LANDING GEAR - LANDING GEAR WARNING HORN REPLACEMENT

The original landing gear warning horn is no longer available. If the landing gear warning horn needs to be replaced, a new landing gear warning horn is available and will require an additional bracket for installation.

MEB-32-02  
Page 1 of 25

Figure 3. 340 Configuration 1 (Sheet 1)

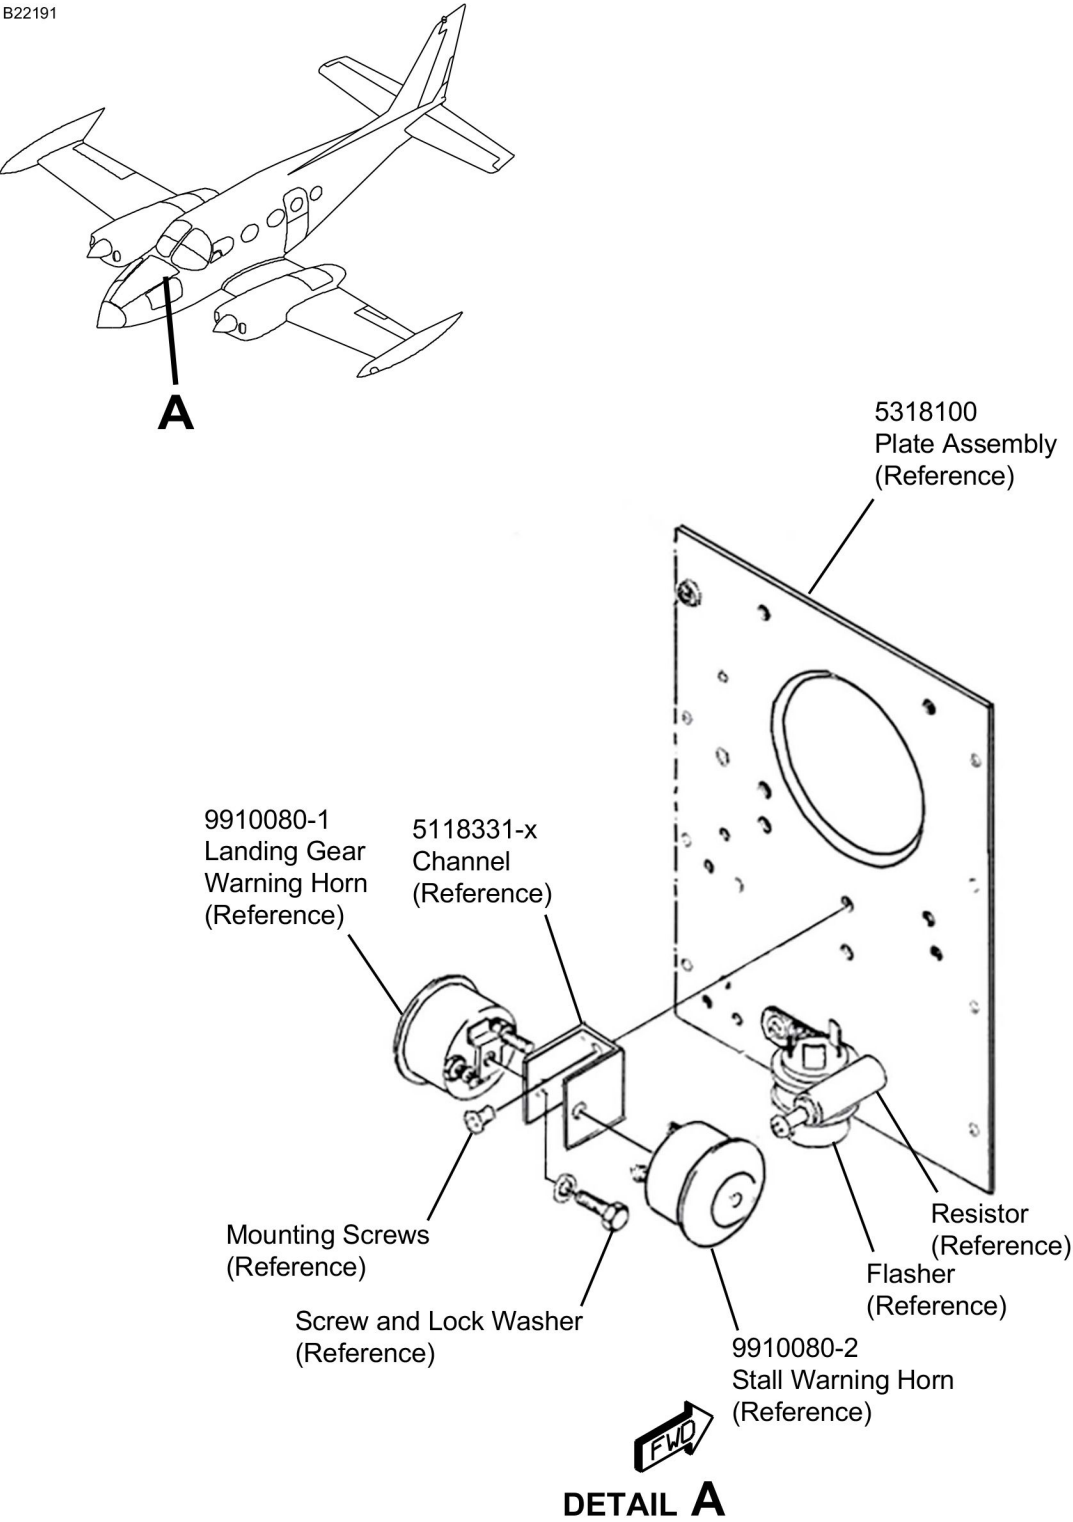
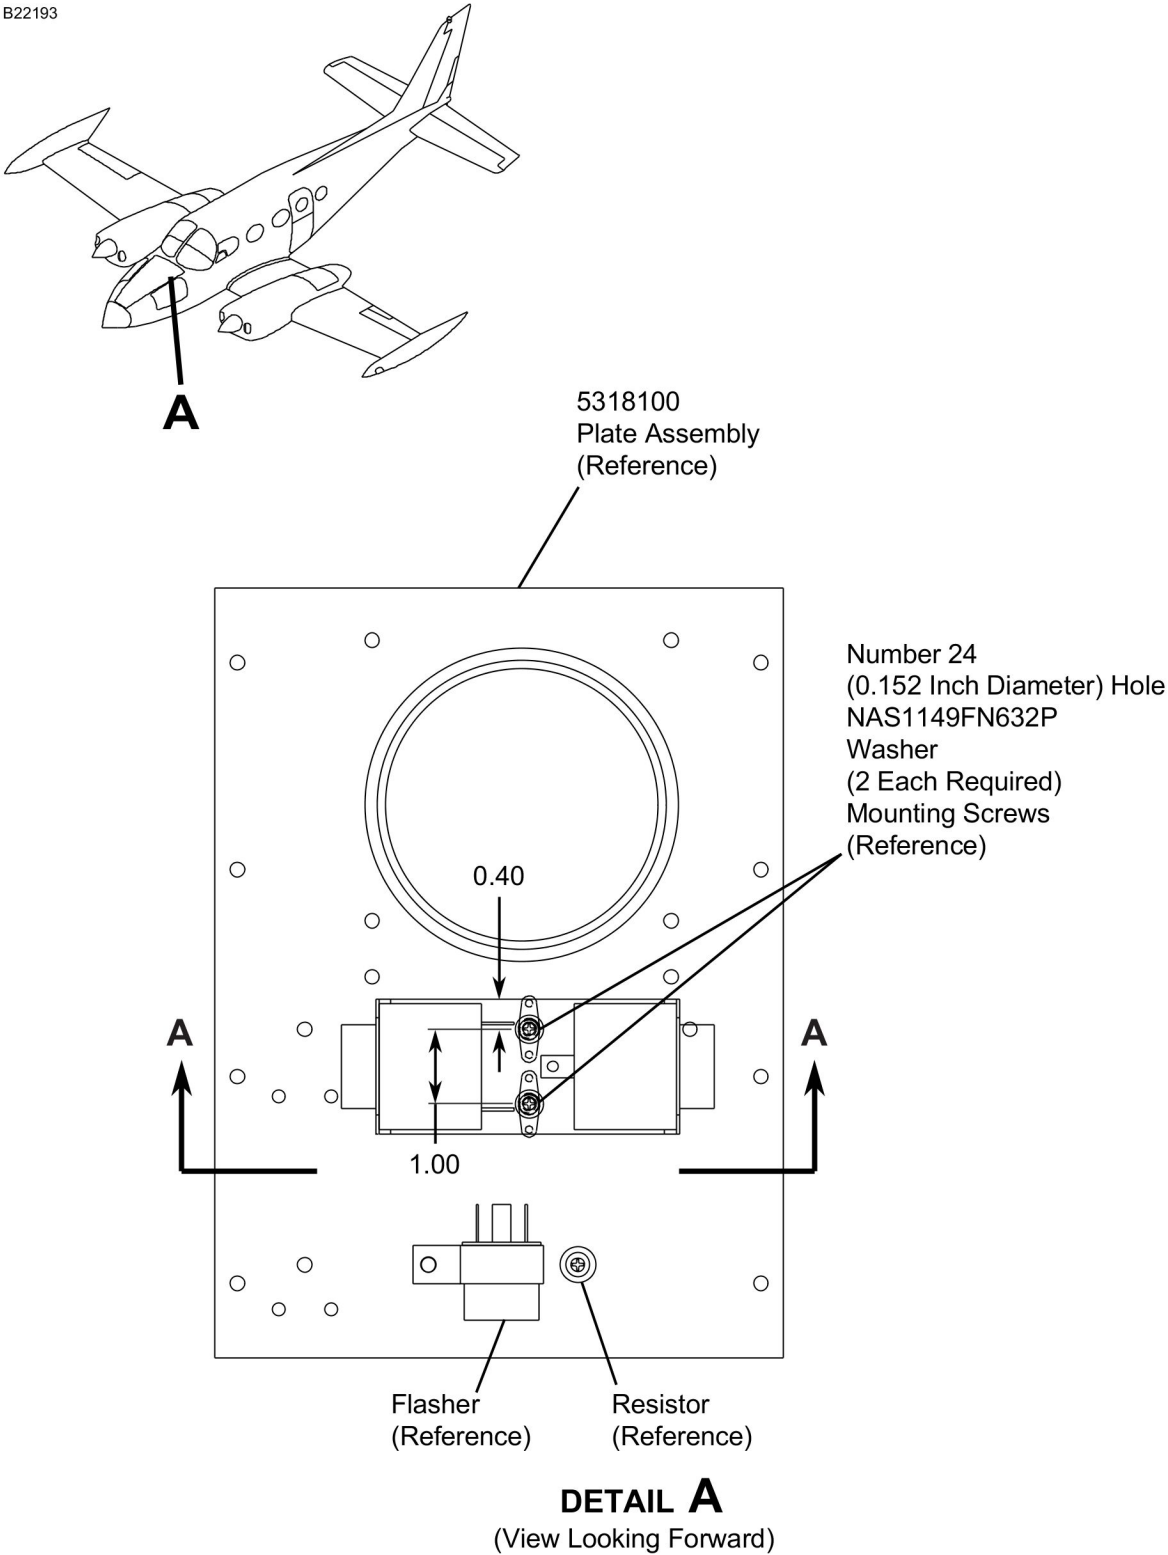
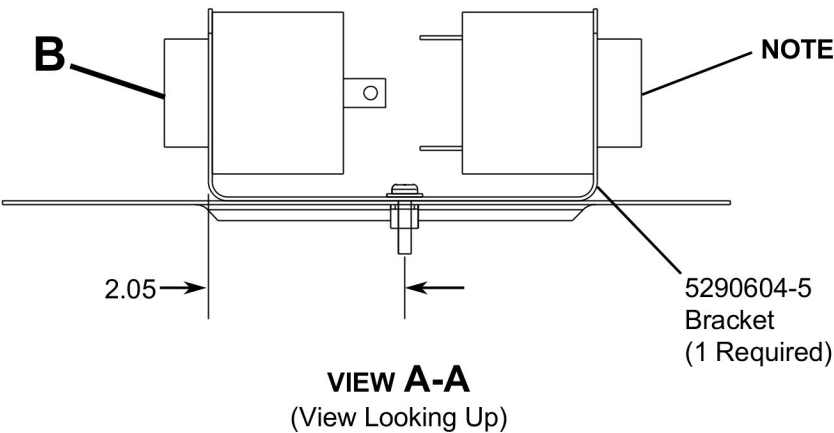
3. (For Model 340 Refer to Figure 1, Sheet 1, and for Model 335/340A Figure 2, Sheet 1.) Remove the 9910080-1 Landing Gear Warning Horn as follows:
- A. Remove and discard the screw and lock washer from the 9910080-1 Landing Gear Warning Horn.
  - B. Disconnect and label the electrical wiring from the 9910080-1 Landing Gear Warning Horn.
  - C. Discard all electrical hardware from the 9910080-1 Landing Gear Warning Horn.
  - D. Discard the 9910080-1 Landing Gear Warning Horn.
  - E. Remove and discard the screw and lock washer from the 9910080-2 Stall Warning Horn.
  - F. Disconnect and label the electrical wiring from the 9910080-2 Stall Warning Horn.
  - G. Discard all electrical hardware from the 9910080-2 Stall Warning Horn.
  - H. Discard the 9910080-2 Stall Warning Horn.
  - I. Remove and keep the mounting screws from the 5118331-X Channel.

- J. Discard the 5118331-X Channel.
4. (For Model 340 Refer to Figure 3, Sheet 1 and 2, and for Model 335/340A Figure 4, Sheet 1 and 2.) Install the 9910080-5 Landing Gear Warning Horn as follows:

- A. (For Model 340 airplanes.) Match drill the two Number 24 (0.152 inch diameter) holes of the 5318100 Plate Assembly to the 5290604-5 Bracket.
  - (1) Deburr the drilled holes from the 5290604-5 Bracket.
  - (2) Apply Color Chemical Film Treatment to all bare metal.
  - (3) Install the 5290604-5 Bracket with the two kept mounting screws and the two NAS1149FN632P Washers into the 5318100 Plate Assembly.
  - (4) Go to Step 4C.
- B. (For Model 335/340A airplanes.) Match drill the two Number 11/64 (0.172 inch diameter) holes of the 5318100 Plate Assembly to the 5290604-5 Bracket.
  - (1) Deburr the drilled holes from the 5290604-5 Bracket.
  - (2) Apply Color Chemical Film Treatment to all bare metal.

- (3) Install the 5290604-5 Bracket with the two kept mounting screws and the two NAS1149FN832P Washers into the 5318100 Plate Assembly.

- C. Install the 9910080-5 Landing Gear Warning Horn into the 5290604-5 Bracket.
- D. Install the knurled nut onto the 9910080-5 Landing Gear Warning Horn.

Figure 5. 340 Configuration 2 (Sheet 1)

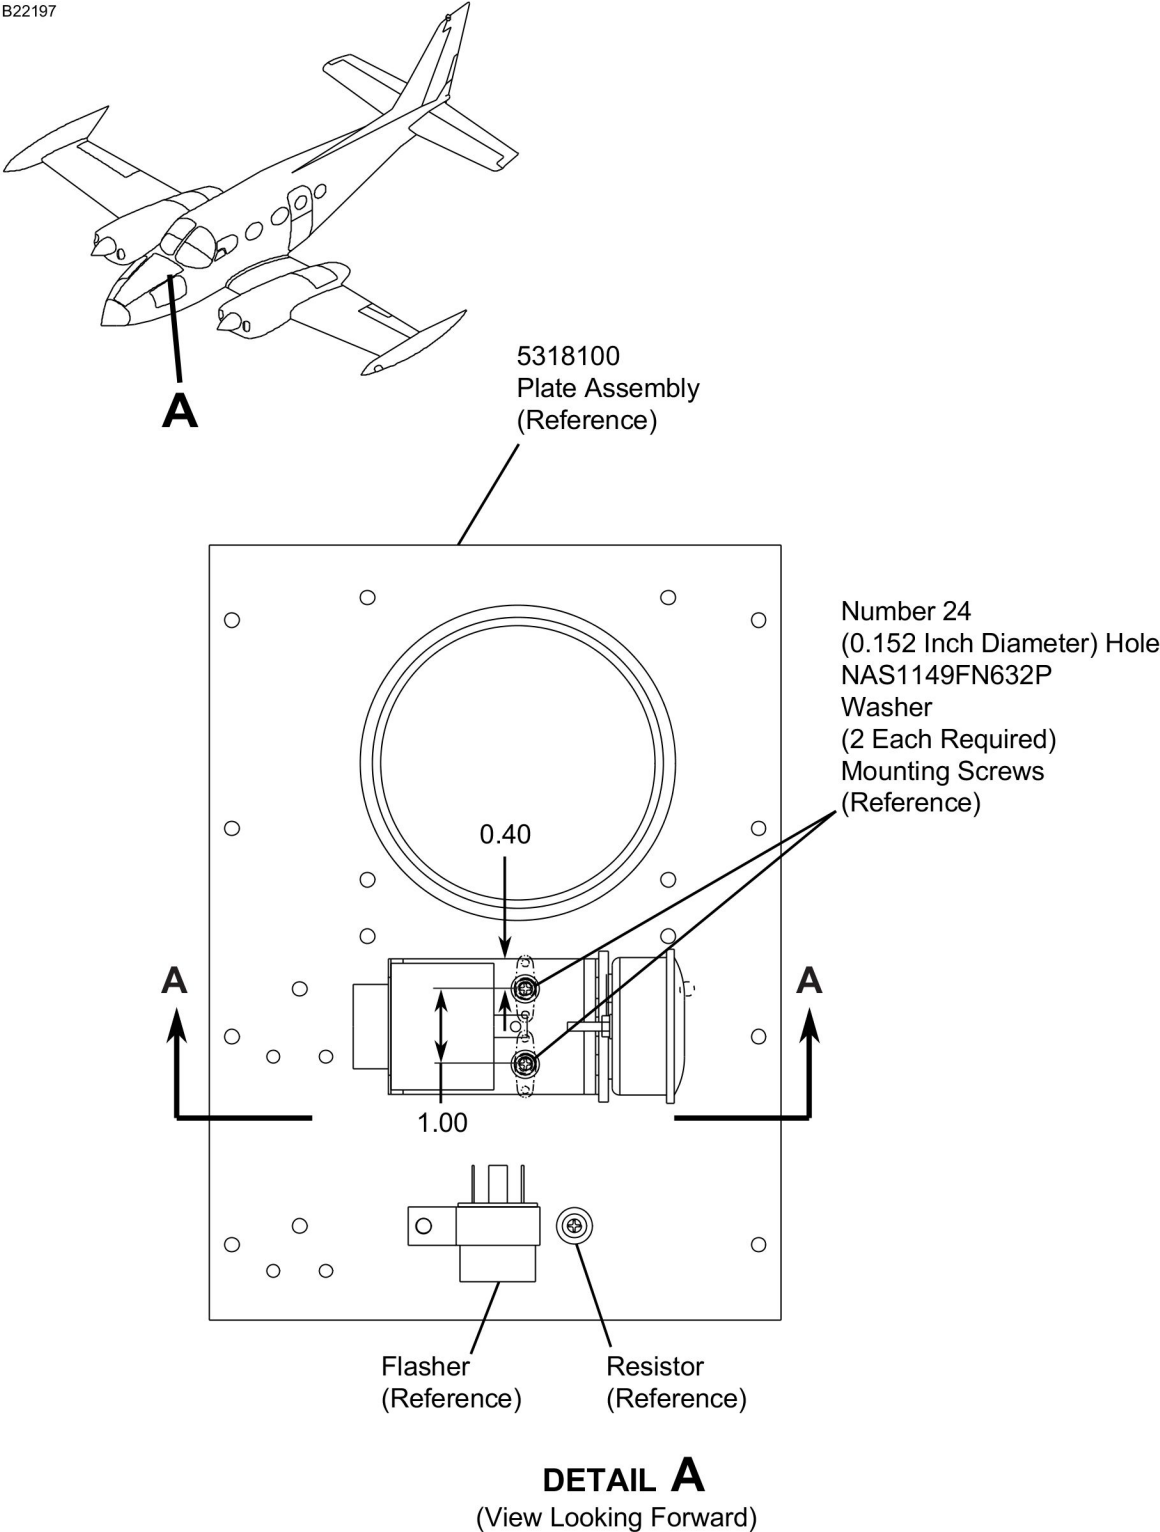
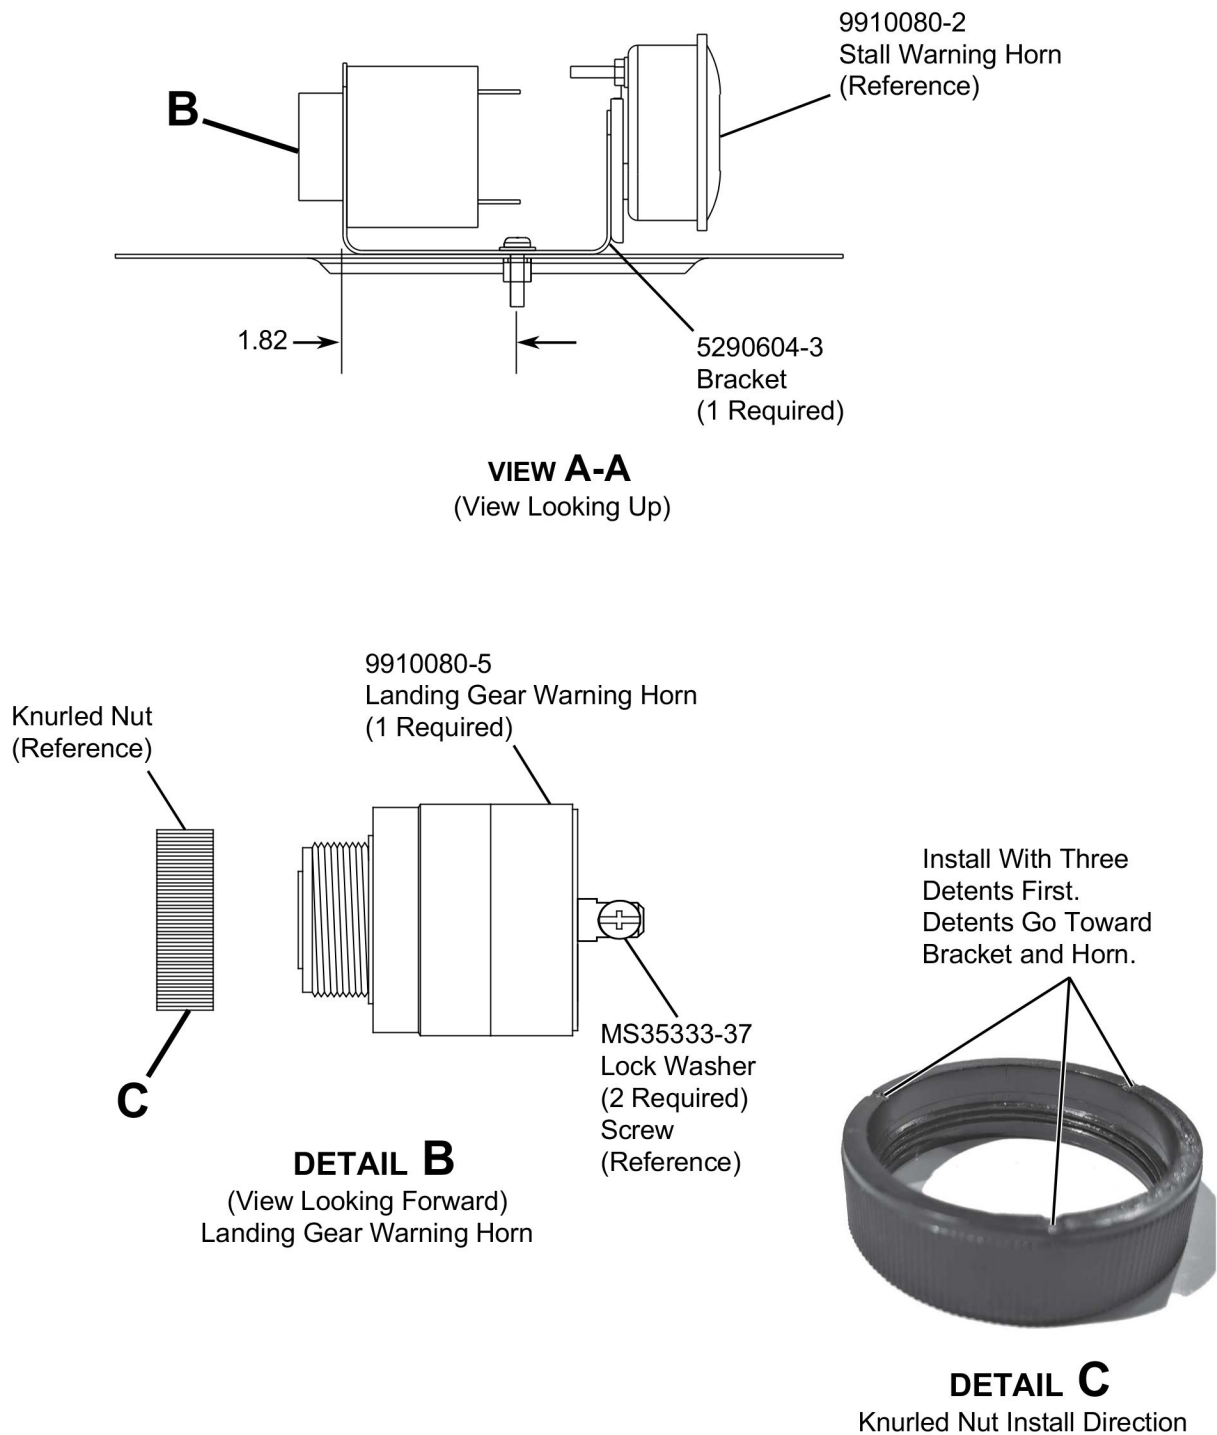
8. (For Model 340 Refer to Figure 1, Sheet 1, and for Model 335/340A Figure 2, Sheet 1.) Remove the 9910080-1 Landing Gear Warning Horn as follows:
    - A. Remove and discard the screw and lock washer from the 9910080-1 Landing Gear Warning Horn.

9. (For Model 340 Refer to Figure 5, Sheet 1 and 2, and for Model 335/340A Figure 6, Sheet 1 and 2.) Install the 9910080-5 Landing Gear Warning Horn as follows:

- A. (For Model 340 airplanes.) Match drill the two Number 24 (0.152 inch diameter) holes of the 5318100 Plate Assembly to the 5290604-3 Bracket.
    - (1) Debur the drilled holes from the 5290604-3 Bracket.

- (2) Apply Color Chemical Film Treatment to all bare metal.
    - (3) Install the 5290604-3 Bracket with the two kept mounting screws and the two NAS1149FN632P Washers into the 5318100 Plate Assembly.

- C. Install the 9910080-5 Landing Gear Warning Horn into the 5290604-3 Bracket.
  - D. Install the knurled nut onto the 9910080-5 Landing Gear Warning Horn.
